ADDENDUM NO. 3

CONTRACT NO. 17-539

**NEW GOLF CART STORAGE FACILITY
AND CLUBHOUSE UPGRADES
MOHANSIC GOLF COURSE
YORKTOWN, NEW YORK**

FLOOR DRAIN

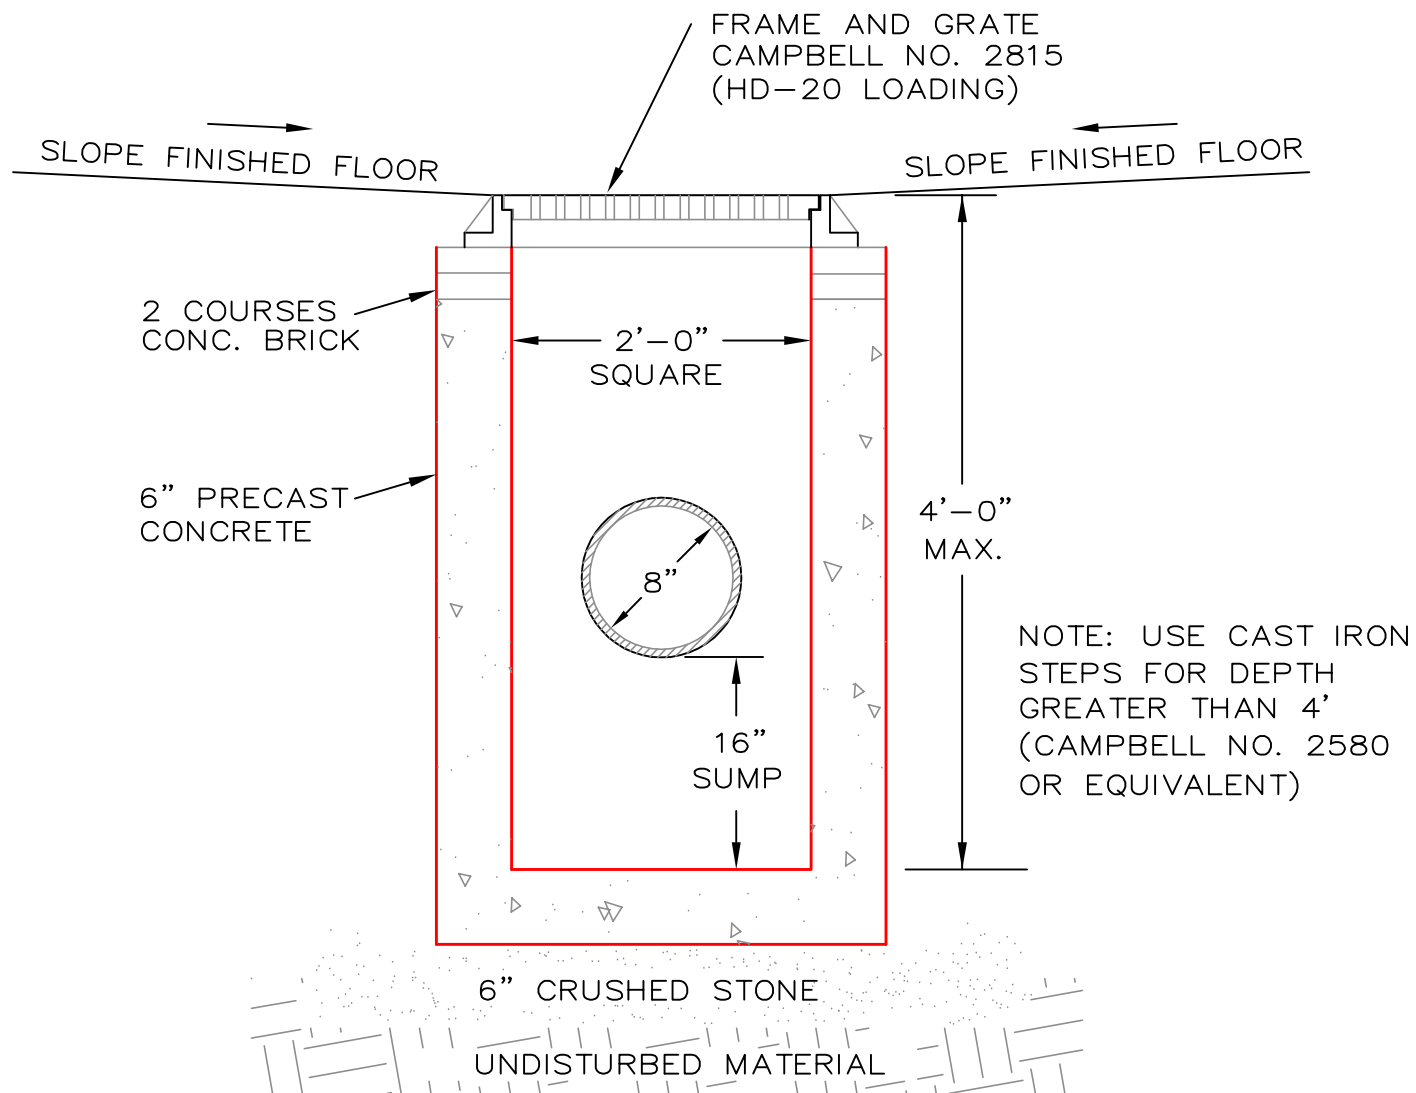
2. 'Who is responsible to install new underground sanitary piping for (4) floor drains in new Golf cart storage bldg.? The piping is indicated on drawing C-102 (no size mentioned).Drawing P-201 does instruct PC to install new Floor Drains.'

It is the responsibility of the Plumber to install the underground waste / sanitary piping to 5'-0" past the building foundation.

The building interior floor drain pipe should be 8" PVC SDR35.

See attached detail for: 'FLOOR DRAIN', which shall be incorporated into the Cart Facility floor slab for all 4 drain inlet locations.
